**To: T10 SAS Protocol Working Group**

**From: Brian Day (LSI)**

**Subject: SAS 2: Only issue BROADCAST(CHANGE) for initial Spinup Hold**

Figure 1 — SP (phy layer) state machine - SATA spinup hold state

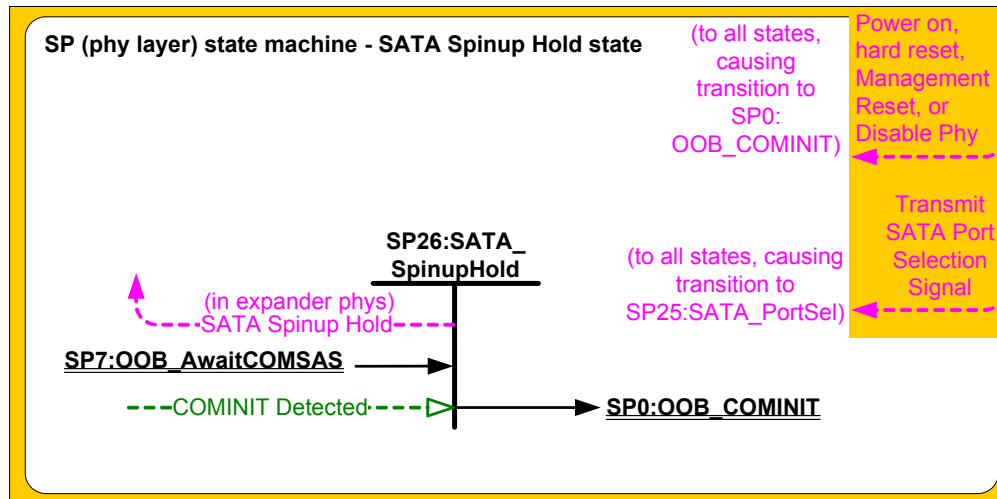
However, SATA drives that implement Asynchronous Signal Recovery (ASR), will generate COMINIT signals very frequently (usually around 10ms), and cause the SP state machine to cycle back through the SP0 to SP26 states. As currently defined, this causes a large number of BROADCAST(CHANGE) primitives to be transmitted by the expander. If the discover process is aborted each time these BROADCASTs are received, the discover process could potentially not complete.

This proposal modifies the rule of when expanders generate BROADCAST(CHANGE) so that it occurs only for the “initial” entry into SP26: SATA\_SpinupHold state.

~~Upon entry into this state, this state shall set the ResetStatus state machine variable to SPINUP\_HOLD.~~

~~If this state machine is in an expander phy, this state shall send a SATA Spinup Hold confirmation to the link layer.~~

Upon entry into this state, this state shall:

- a) if the ResetStatus state machine variable is set to SPINUP\_HOLD, not change the ResetStatus state machine variable; or
- b) if the ResetStatus state machine variable is not set to SPINUP\_HOLD:
  - A) set the ResetStatus state machine variable to SPINUP\_HOLD; and
  - B) if this state machine is in an expander phy, send a SATA Spinup Hold confirmation to the link layer.
